**ACME TOWNSHIP PLANNING COMMISSION MEETING
ACME TOWNSHIP HALL
6042 Acme Road, Williamsburg MI 49690
June 08, 2015 7:00 p.m.**

b) VGT-Presentation of Storm Water Final Engineering Plans: Township Planner

Grand Traverse Town Center Development Storm water Plan Review

Prepared for Beckett and Raeder, Inc.
Project Name Grand Traverse Town Center Storm Water Plan Review
Project Number j1536061.00
Project Manager John Iacoangeli/ Beckett & Raeder
 Adam Crowe/ Cardno
Date 05/15/2015

BASIN #1 DETAIL

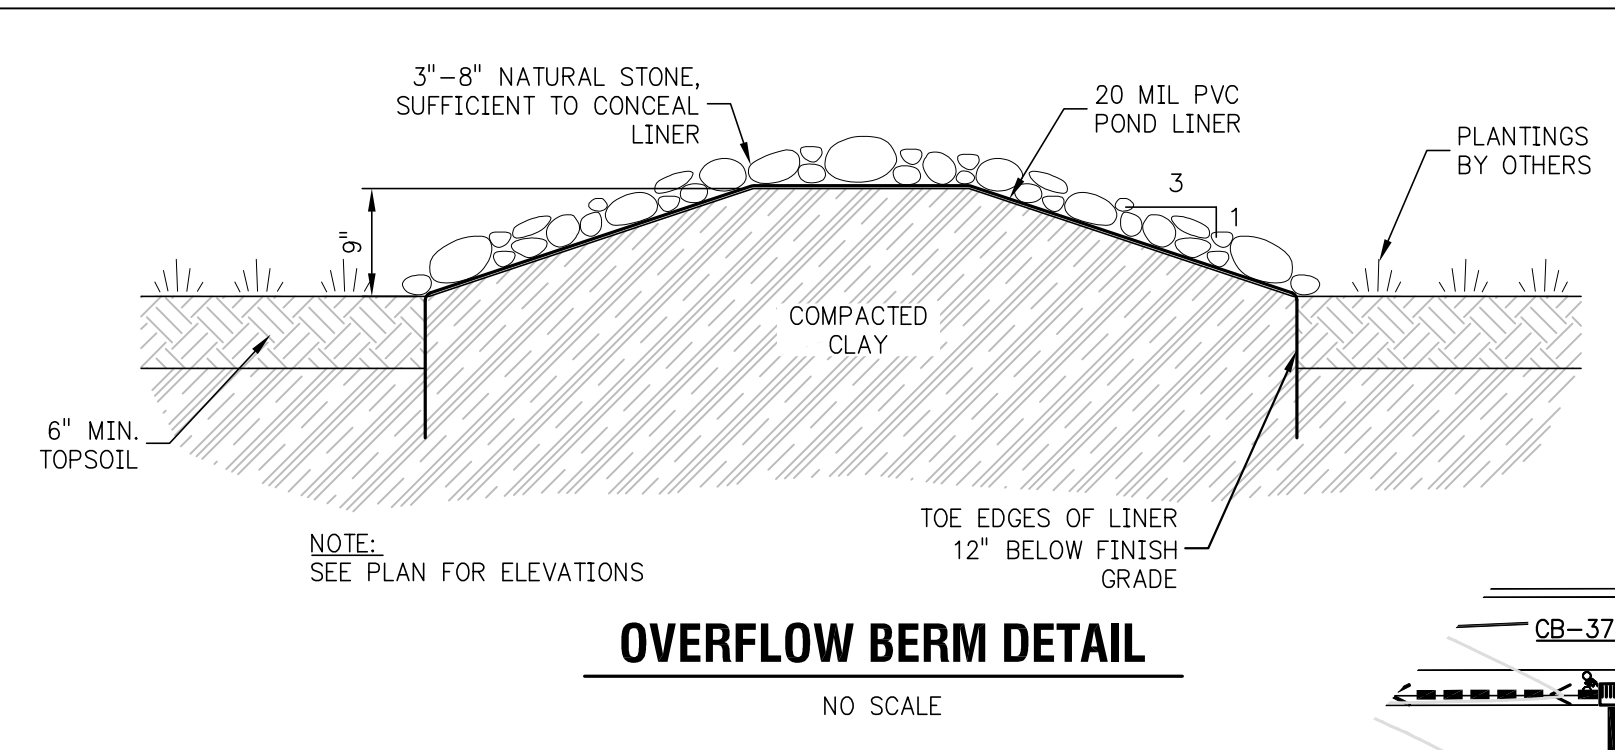
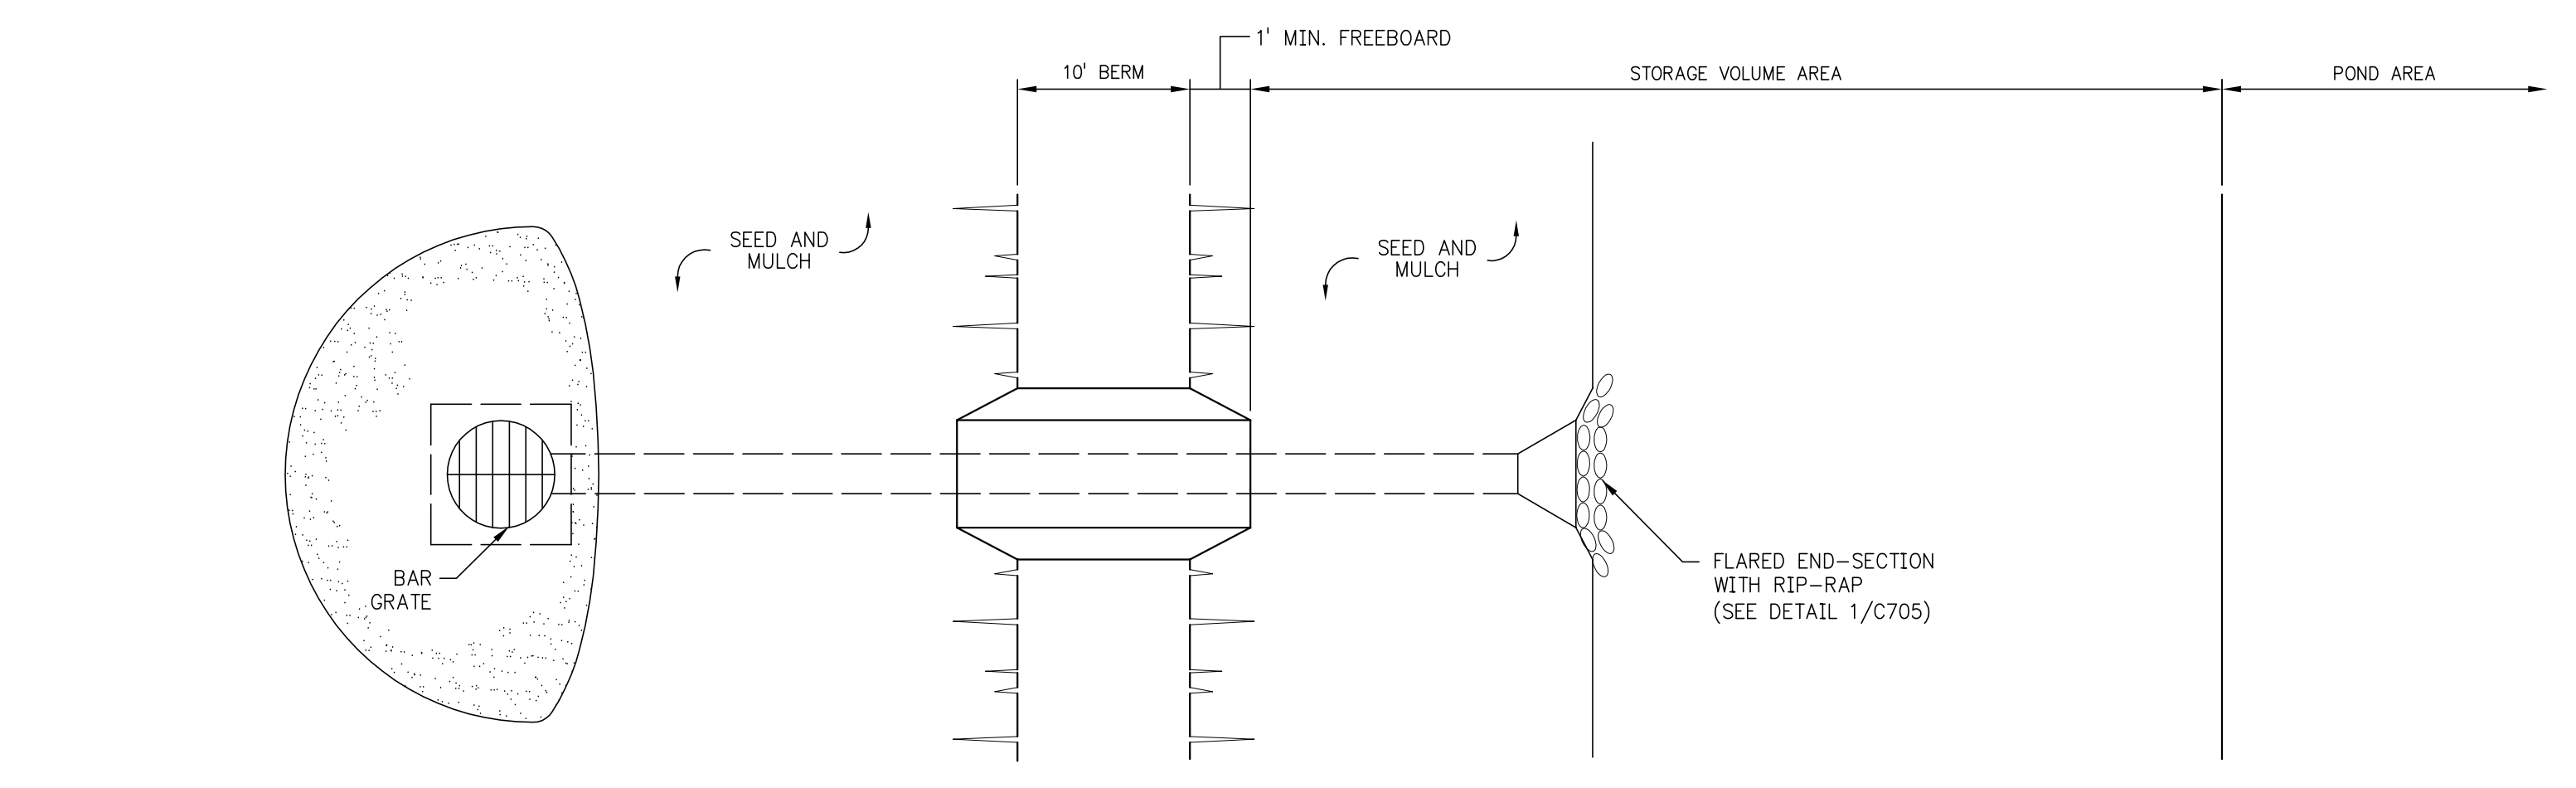
The latest drawings provided for review are plan sheets C312 “Basin #1 Detail” and C313 “Basin #2 Detail” revision no. 6 dated 05/05/2015. Engineering calculations for Watersheds #1 and #2 dated 05/05/2015 are also provided. An “Overall Grading Plan”, sheet C300 dated 09/05/2012 was previously provided.

The calculations show design criteria requirements of a storm water detention system as required by the Acme Township Storm water Control Ordinance. This criterion includes "Treatment Volume" and "Flood Control Volume" requirements. The "Treatment Volume" requirement is the volume of runoff from the 1.5 year, 24 hour rainfall event with post development conditions or a minimum of 5,000 cft per impervious acre. A maximum release rate of .05 cfs/impervious acre is also given. In both watersheds, the minimum volume requirement of 5,000 cft per impervious acre controls. For watershed #1, the minimum volume required is 90,950 cft with a maximum release rate of .91 cfs. For watershed #2, the minimum volume required is 27,650 cft with a maximum release rate of .27 cfs. The plans and calculations show both detention basins #1 and #2 are capable of storing the minimum treatment volumes with a release rate below the maximum allowed.

Overall, the detention basins that have been constructed have the capacity to detain the required runoff volumes from the phase 1 build-out to the Ordinance standards. This runoff is also released downstream at rates below the maximum allowed per the Ordinance. As-built plans need to be provided when the proposed modifications are completed and future build-outs need to be analyzed as described.

- *As-built plans for phase 1 are required that accurately show and include the following: the boundary for each watershed, total acreage within each watershed boundary, and built-out impervious area within each boundary for phase 1. Specifically, C300 needs to be updated to reflect the noted items above and the latest C312 and C313 revisions.*
- *As future build-outs are analyzed for storm water, additional pre-treatment techniques should continue to be employed for the individual future build-out phases.*
- *As future build-outs are analyzed for storm water, calculations for the existing basins will need to be updated as well. Further modifications to the outlet structures may be necessary to keep release rates below the maximums allowed.*

BASIN #1 PLANTING PLAN

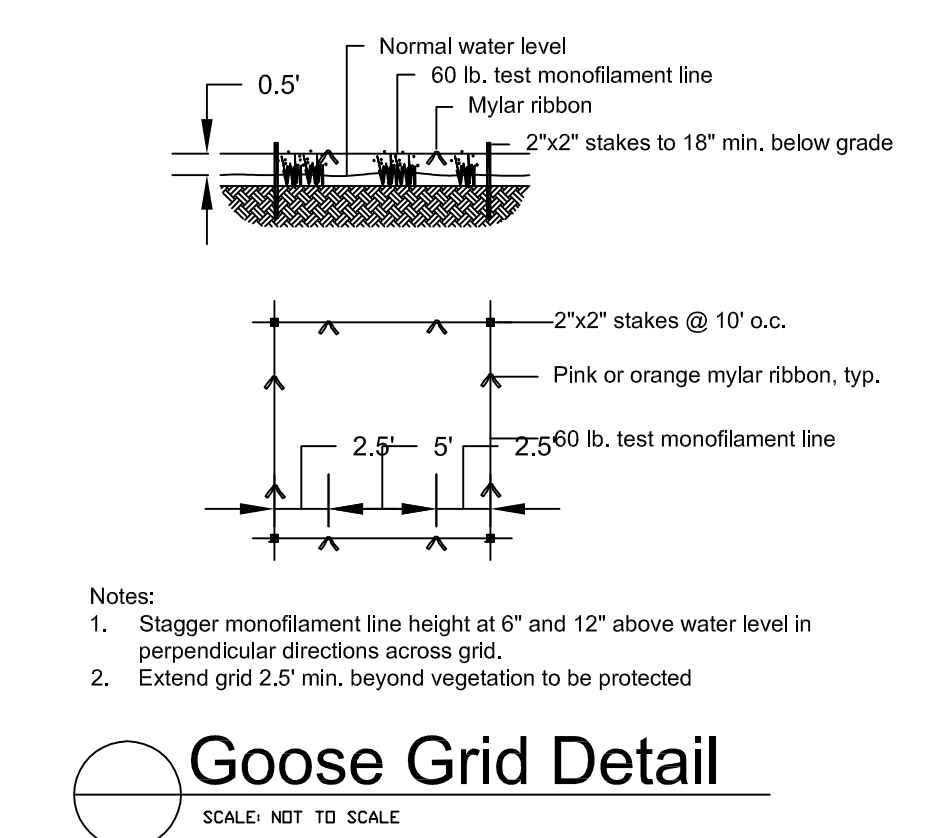
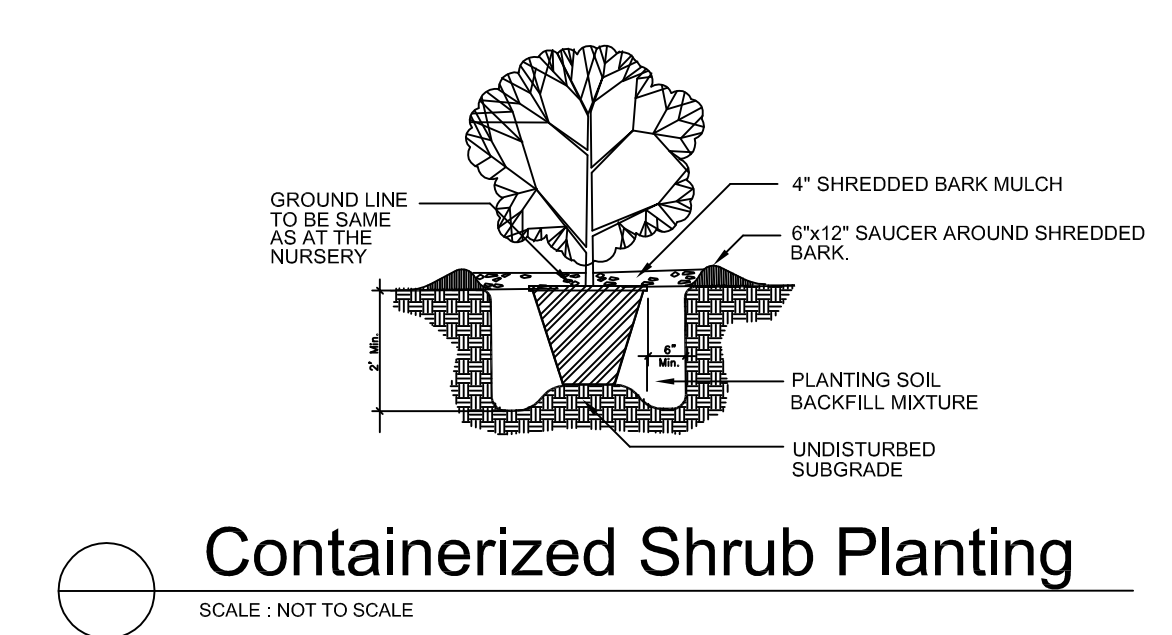
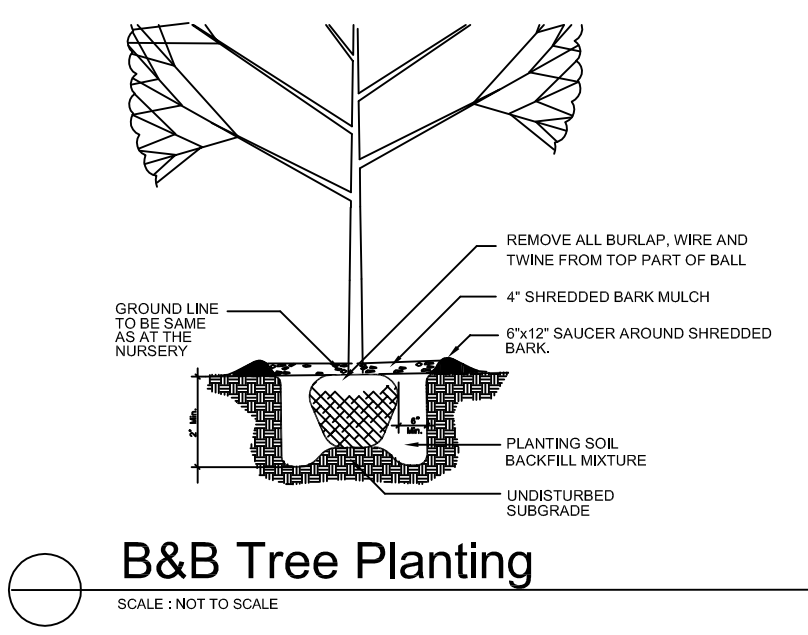
It is noted that other proposed modifications regarding vegetation have been prepared and are included in sheets C613 “Basin #1 Planting Plan” and C614 “Basin #2 Planting Plan”. Both drawings are Revision #2 dated 05/07/2015 prepared by King and Macgregor. It is understood commentary regarding those plans as well as commentary on the wetlands and treatment components of the storm water system has been prepared by Cardno Inc. for your consideration.

The intended goal of the most recent plan revisions to both basins (05/05/2015) has been to more closely resemble the approved preliminary plan from the standpoint of surface area per habitat type and the three tier concept. The functional benefits of wetland habitats on water quality and groundwater recharge are directly proportional to the amount of habitat present in most cases. To this end the final plan design with the additional modifications proposed has increased or maintained surface area of each habitat type in both except for semi wet habitats. The semi wet habitat is reduced from preliminary plans because portions of the swale will be converted to high and low marsh habitat.

With the addition of the final plan modifications (05/05/2015) the treatment system will retain the three tier concept. Armored and compacted clay berms will provide impoundment and retention of hydrology sufficient to create a moist soil environment conducive to wetland development. These berms will provide for flow through as well during storm events, while providing a functional benefit of velocity decrease. Within each basin, the wetland cell modifications are proposed within low gradient reaches that will provide the highest probability of successful establishment for these habitat types.

It is expected that the proposed modifications to the final plan will be successful through diligent manipulation of hydrology, soil augmentation, species selection and implementation of the five year monitoring program. In compliance with the SUP, a five year wetland monitoring plan supplemented by a maintenance plan that will continue in perpetuity has been agreed to by The Village at Grand Traverse LLC (TVGT) as per an agreement signed July 24, 2013. Specific performance criteria for vegetation establishment and persistence, sediment accumulation thresholds and relative percent native species to invasive should be based on standard MDEQ mitigation monitoring performance criteria modified to suit this application. These criteria should be stated prior to the establishment of year one vegetation to avoid ambiguity in the monitoring and maintenance program.
